Our Ref: R/2021/5/D & R/2017/28/E
File No: 2023/464259
Your Ref: SSD-19989744-Mod-1 & SSD-8993-Mod-4

**Advice on Modifications - SCEGGS Darlinghurst
SSD-19989744-Mod-1 and SSD-8993-Mod-4**

Figure 1: Portion of the western elevation that should remain as copper cladding.

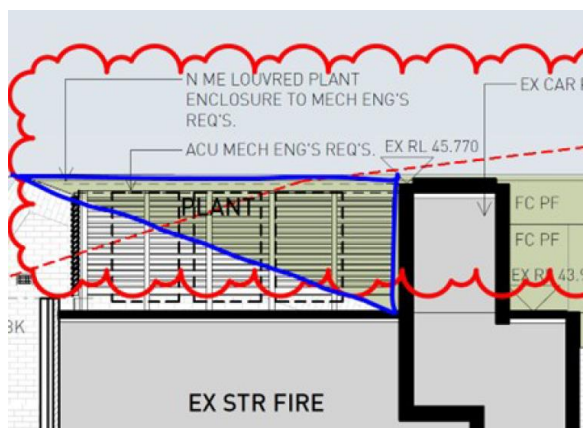
- The increase in the lift shaft width encroaches into the roof eave. While there are adverse visual impacts from the lift cutting into the roof and this is not an ideal design outcome, its visibility is minimal due to the setback from the street.
- The proposal includes changing the fascia cladding on the western elevation from copper to fibre cement with paint finish. The elevation highlights a portion of the changed materials closer to St Peter Street. It is recommended that this portion which has visibility from the street remain as copper cladding to maintain uniformity with the external roof material.
